## CITY OF PORTLAND

**City of Portland, Maine - Building or Use Permit Application**

Past Use: 3 unit residential	Proposed Use: 3 Unit Residential- Restoration & remodel after fire <i>legal use - 3 dwelling units</i>	Permit Fee: \$1,580.00	Cost of Work: \$156,000.00	CEO District: 1
		FIRE DEPT: <input checked="" type="checkbox"/> Approved <input type="checkbox"/> Denied <i>See Conditions</i>	INSPECTION: Use Group: R2 Type: SB <i>IBC-2003</i>

**Addendum for Bradstreet Residence, 29 Merrill Street, Portland**

(Figure 4)

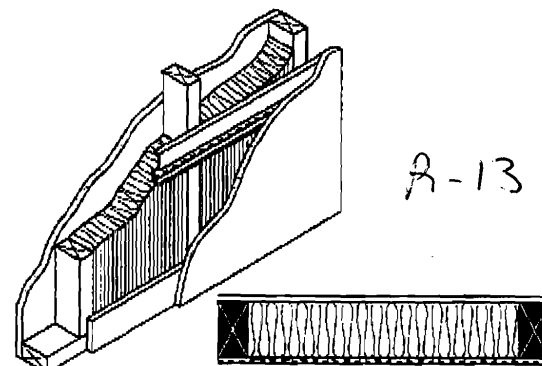
1/29/2007-jmb: Shane Bradstreet came in to submit structural plans from Shelley Eng. I asked for pdf files or 11x17 reduction. The additional structural reinforcement is for a future 4th floor expansion, which will NOT be approved on this permit. Also need the details on the common and separating wall sound transmission.

2/1/2007-jmb: Shane B. Came in with the specs on the common wall construction that meet STC 50 and 1 hour rating, ok to issue

#### **Product Description for Roof Hatch**

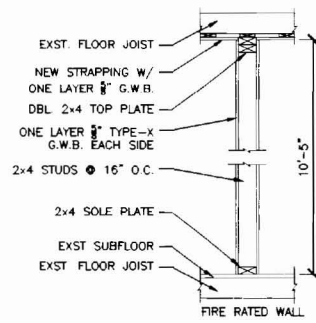
12/1/2006-jmb: Contacted Shane on submittals from 11/30...need wall assembly info and design pro to determine a listing....still need roof hatch details to code.

Acudor A38104 A-Series Roof Hatch 30 x 96 Aluminum Acudor Roof Hatches are designed to provide convenient, economical access to the roof of a building. Available in prime coated galvanized steel or aluminum. Our hatches are designed with safety, durability, and ease of operation in mind. Acudor A38104 A-Series Roof Hatch Optional Features: Acrylic domes Louvered Curbs Stainless Steel Hardware Curb Mounted Modified Curb for Metal Building Acudor A38104 A-Series Roof Hatch Specifications: Roof Hatch Cover: 14 gage galvanized steel / .125 aluminum in box type design with 1" rigid fiberglass insulation and 22 gage galvanized steel / .040 aluminum cover liner. Continuous santoprene weather / draft seal is attached to inside of cover to provide a flush, tight fit. The cover is designed to support a live load of 40 pounds/sq.ft. Roof Hatch Curb: 14 gage galvanized steel / .125 aluminum with 1" rigid fiberglass insulation at curb exterior. Curb is 12" high, and has 3-1/2" wide mounting flange with pre-drilled holes. Roof Hatch Hinge: Steel butt hinges with brass pin. Roof Hatch Opening Device: Fully enclosed compression spring operators allow cover to open and close easily. Automatic hold open arm with red vinyl grip release keeps cover in open position when needed, and allows for easy control when closing hatch cover. Roof Hatch Latch: Self-latching outside turn handle with inside lever handle permits cover to always latch securely. Inside and outside padlock provisions allow for extra security. Roof Hatch equipped with safety railings for easy exterior access\* Roof Hatch Finish: Galvanized steel: prime painted with rust-inhibiting grey primer. Aluminum: mill finish. Convenient weather-tight access to roof Insulated cover and curb Available in galvanized steel and aluminum \* Dimensions are W x H

3 ROOF DECK DETAIL  
A2 N.T.S.

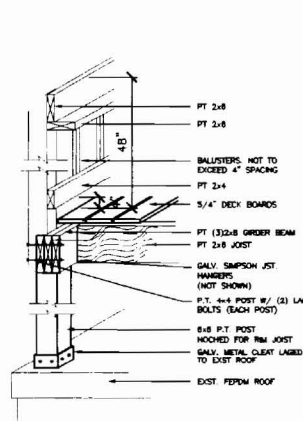
10/27/2006-jmb: Received addendum letter....no information on the deck and the separation walls show not STC rating or UL listing. Need more details on roof hatch and code compliant stairs.

##### **Revisionment of Deck detail:**

Dimensions of Deck will decrease, 21'-7" wide by 12' long, includes 6x6 PT posts every 4' along exterior walls, continued 2x6 supports to foundation
